**REQUEST FOR CHANGE TO TECHNICAL SPECIFICATIONS
OSCILLATION POWER RANGE MONITOR (OPRM)
HOPE CREEK GENERATING STATION
FACILITY OPERATING LICENSE NPF-57
DOCKET NO. 50-354**

**REQUEST FOR CHANGE TO TECHNICAL SPECIFICATIONS
OSCILLATION POWER RANGE MONITOR (OPRM)**

**HOPE CREEK GENERATING STATION
FACILITY OPERATING LICENSE NPF-57
DOCKET NO. 50-354
REQUEST FOR LICENSE AMENDMENT**

TECHNICAL SPECIFICATION PAGES WITH PROPOSED CHANGES

THERMAL POWER VERSUS CORE FLOW
FIGURE 3.4.1.1-1

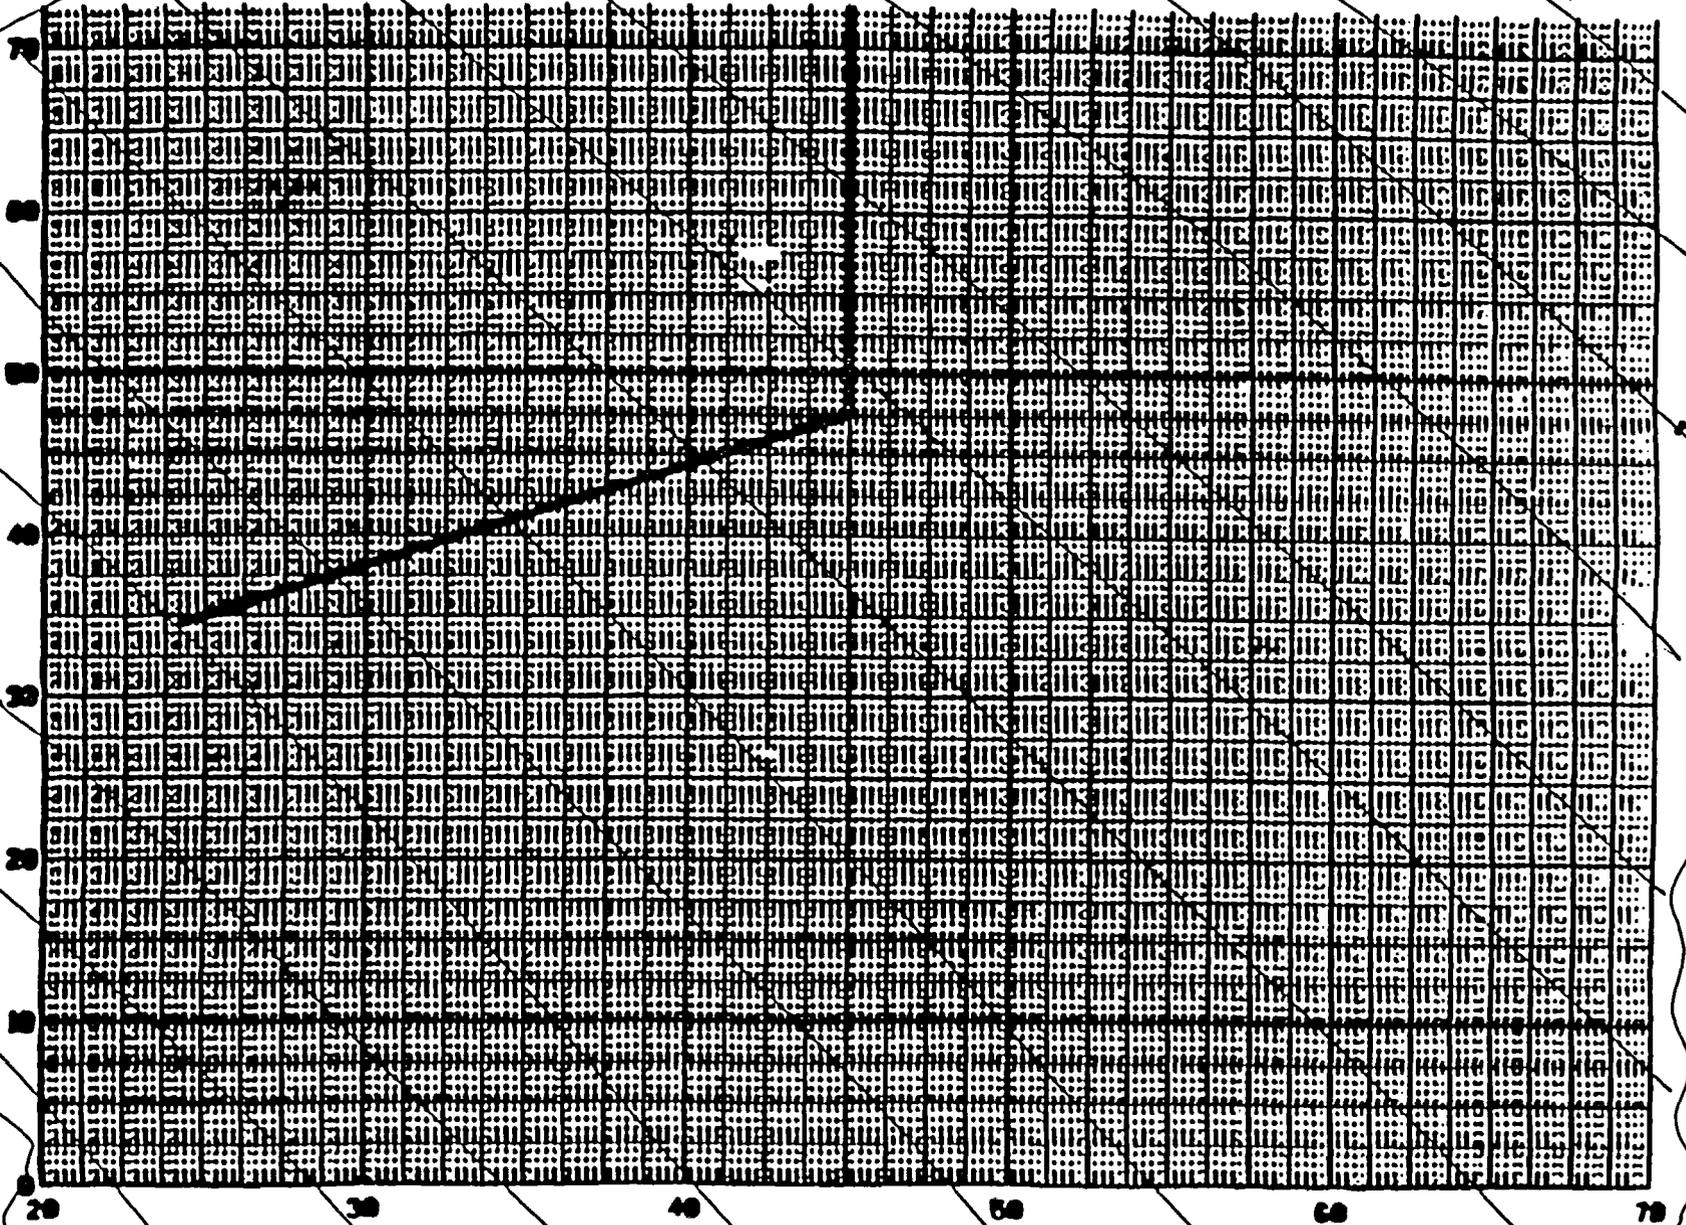
2. TS 3/4.4.1, "Recirculation System," is revised to remove requirements restricting operation consistent with the application of the OPRM Option III as the long term solution to the thermal-hydraulic (T-H) instability issue. Figure 3.4.1.1-1, Thermal Power Versus Core Flow, is deleted together with requirements for monitoring local neutron flux noise and limiting the duration of entry into regions of the power/ flow map associated with the detection, suppression or prevention of thermal-hydraulic instability.

Analyses have been performed to confirm the stability boundary defined in Technical Specification Figure 3.4.1.1-1 at several power/flow statepoints and burnups throughout the current operating cycle. Upon removal of Figure 3.4.1.1-1 from the TS, similar analyses will continue to be performed that will

- a. ~~Total core flow greater than or equal to 45% of rated core flow, or~~
- b. ~~THERMAL POWER less than or equal to the limit specified in Figure 3.4.1.1-1.~~

~~d. Core flow is greater than 40% when THERMAL POWER is greater than the limit specified in figure 3.4.1.1-1.~~
